Appendix 1 – Planning Applications

Backwell Parish Council Planning Committee Meeting 20th August 2026

Agenda items 2.1.

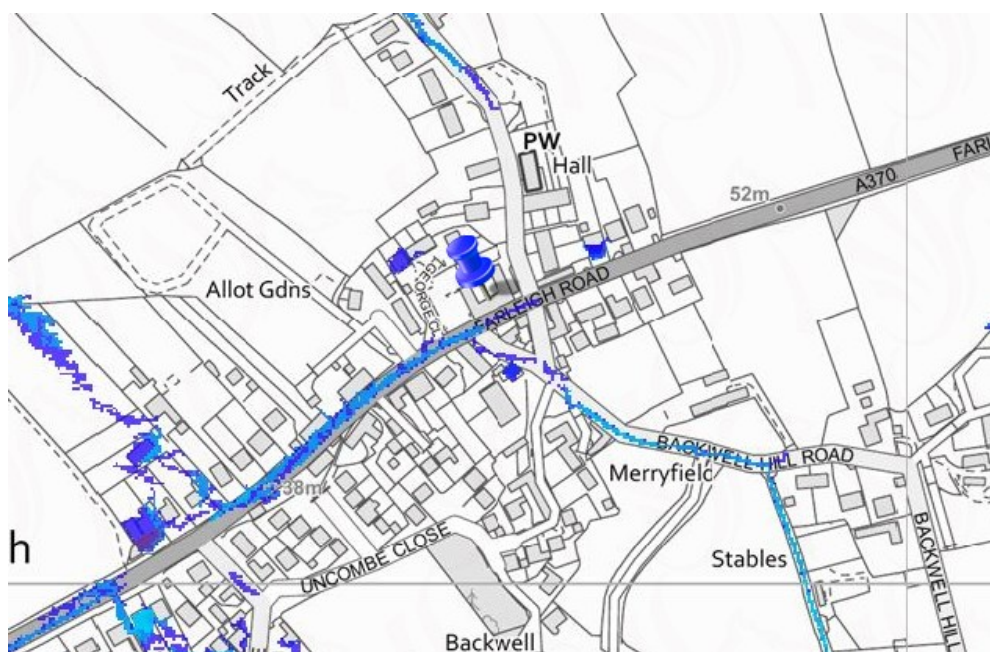
Officer Referral -Given the site's sensitive position within SAC Consultation Zones A and B, BPC requests the formal views of the NSC Ecology Officer to ensure full compliance with Habitat Regulations Assessments (HRA) before any consent is granted.
